THE CORPORATION OF THE CITY OF NIAGARA FALLS

ADDENDUM #1

**RFP20-2019
SUPPLY & INSTALLATION OF NEW
PLAYGROUND ARTIFICIAL TURF SAFETY SURFACING**

Drawing No.
PD2-12A

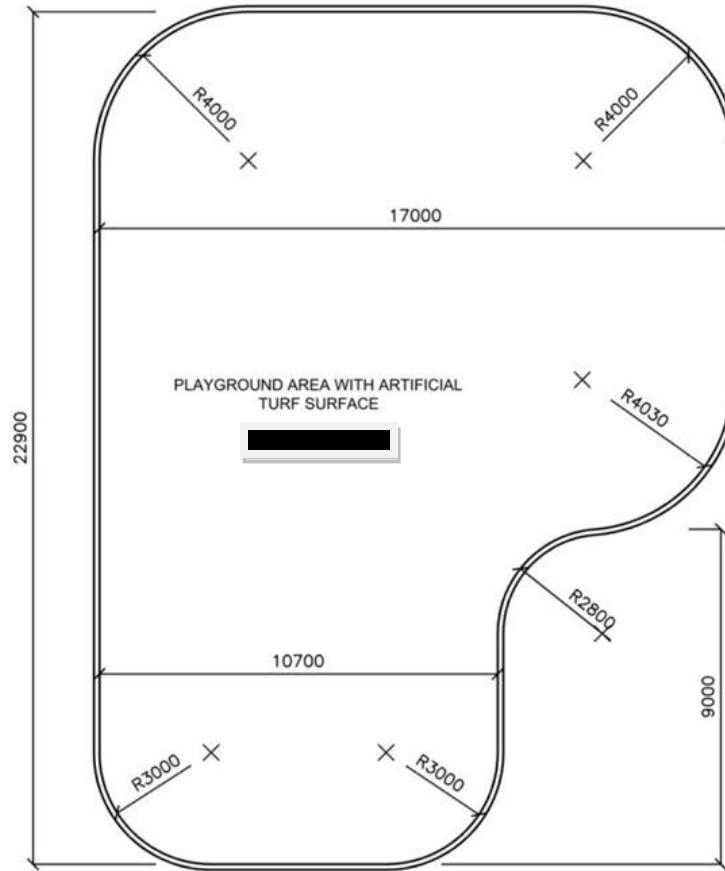
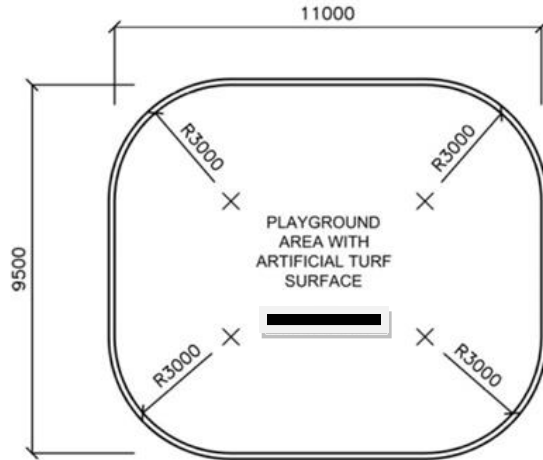
Design Measurements – are the sizes in the playground photographs to remain similar? Has this accounted for product waste based on the 15' roll length?

PD2-12A (approx. 320m²) is used at Alpine Park, Fern Park, Glengate Park, Meadowvale Park and Theresa Park

The photographs provided are for site locations only. The sites are going to be redeveloped outside of this Contract. The three new playground configuration drawings are provided with this addendum as PD2-12A, PD2-12B and PD2-12C.

The double line in the detail plans represents the perimeter curb. All measurements shown are the inside edge of curb.

Drawing No.
PD2-12B

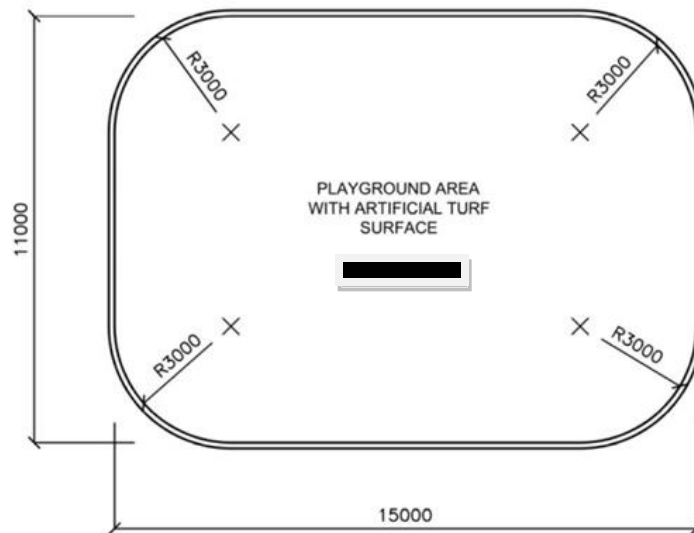
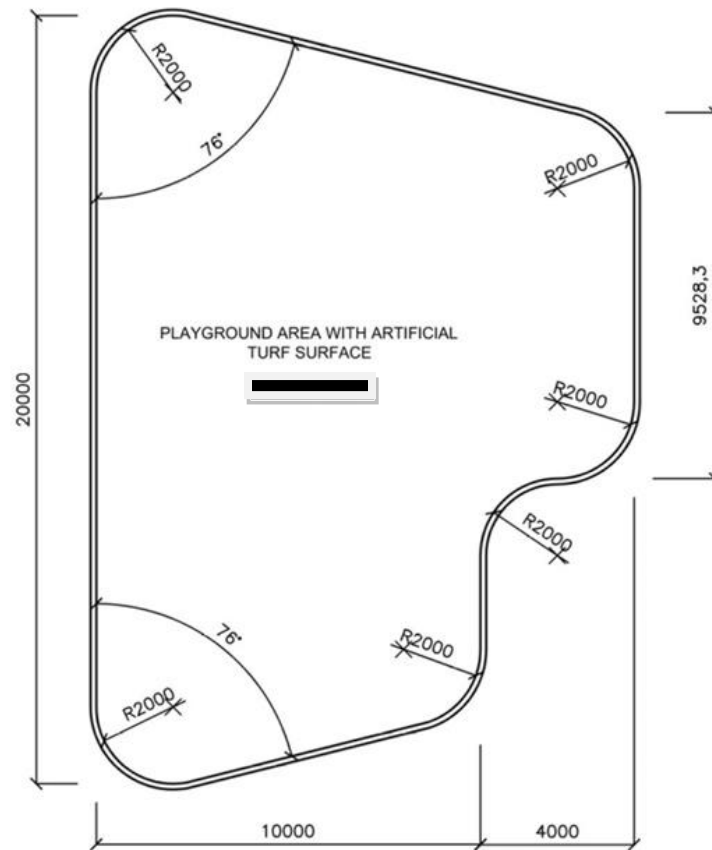
PD2-12B (approx. 250m²) is used at Althea Park, Brookfield Park and Corwin Park.
